<b>Title - Sujet</b> Building Modernization - Phase 2	
<b>Solicitation No. - N° de l'invitation</b> EC015-140977/A	<b>Amendment No. - N° modif.</b> 006
<b>Client Reference No. - N° de référence du client</b> R.039554.001	<b>Date</b> 2013-09-20
<b>GETS Reference No. - N° de référence de SEAG</b> PW-\$PWB-020-3297	
<b>File No. - N° de dossier</b> PWB-3-36036 (020)	<b>CCC No./N° CCC - FMS No./N° VME</b>
<b>Solicitation Closes - L'invitation prend fin</b> <b>at - à 02:00 PM</b> <b>on - le 2013-09-26</b>	<b>Time Zone</b> Fuseau horaire Atlantic Daylight Saving Time ADT
<b>F.O.B. - F.A.B.</b> <b>Plant-Usine:</b> <input type="checkbox"/> <b>Destination:</b> <input type="checkbox"/> <b>Other-Autre:</b> <input type="checkbox"/>	
<b>Address Enquiries to: - Adresser toutes questions à:</b> Donovan, Janine PWB	<b>Buyer Id - Id de l'acheteur</b> pwb020
<b>Telephone No. - N° de téléphone</b> (506) 636-5347 ( )	<b>FAX No. - N° de FAX</b> (506) 636-4376

Addenda numéro 6

Public Works and Government Services Canada Travaux publics et Services gouvernementaux Canada	Drawing title	Titre du dessin <b>REVISED MILLWORK ENLARGEMENT ROOM 138</b>		designed	conçu	date	2013-09-19
	project <b>BUILDING MODERN

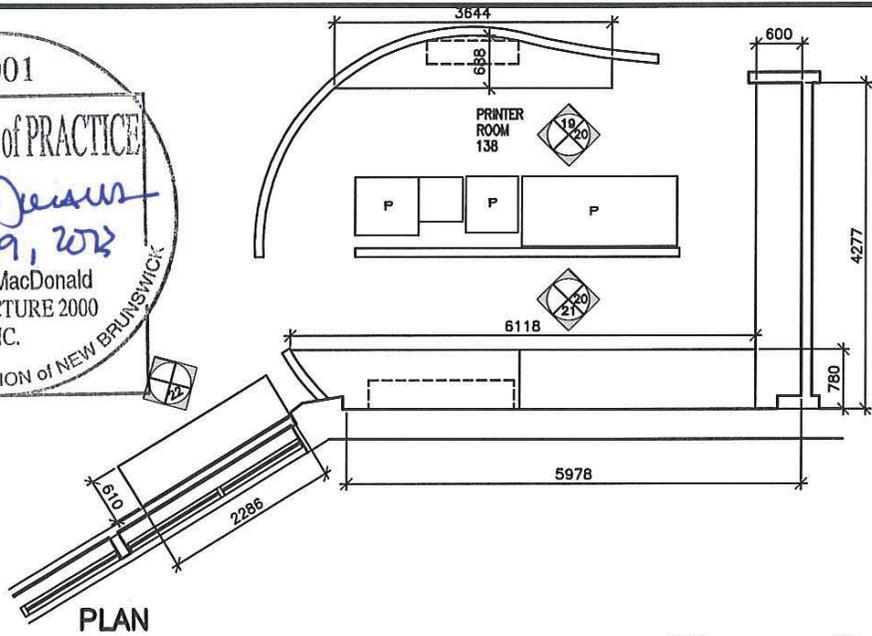
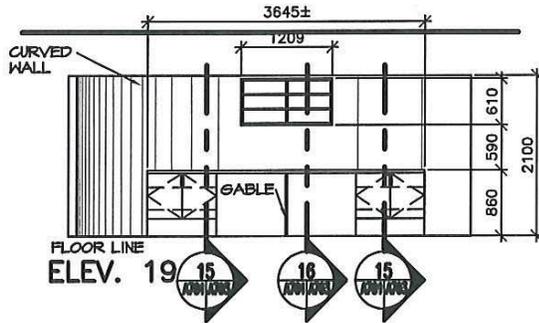
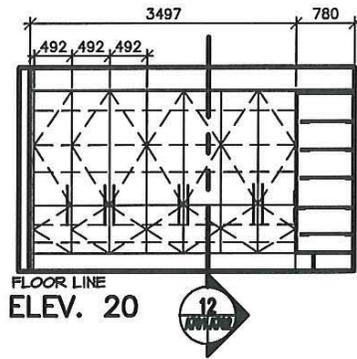
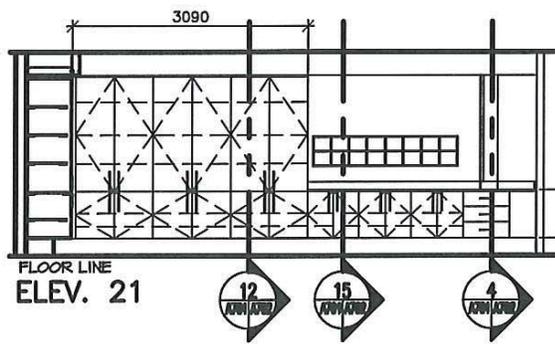
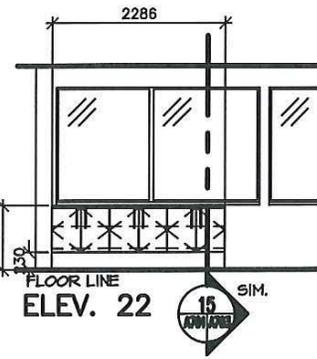
- 
- Q6:** In room 138, the large scale floor plan and elevation 21 on detail 5/A-701 do not correspond with each other.
- R6:** Revised: See attached sketch ASK-4.

**MILLWORK ROOM 138**

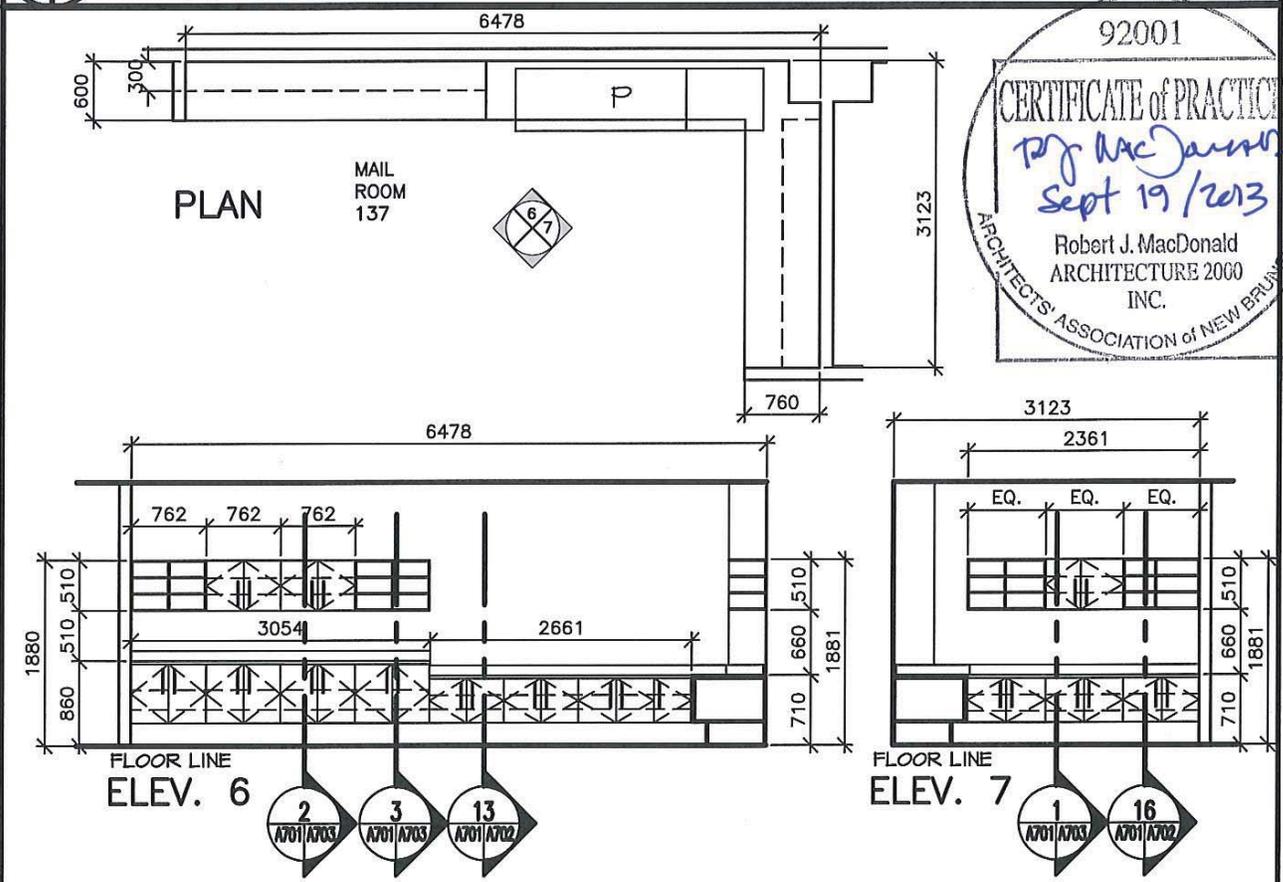
- Q7:** In room 137, the large scale floor plan and elevation 6 & 7 on detail 6/A-701 do not correspond with each other.
- R7:** Revised: See attached sketch ASK-5.

**MILLWORK ROOM 137**
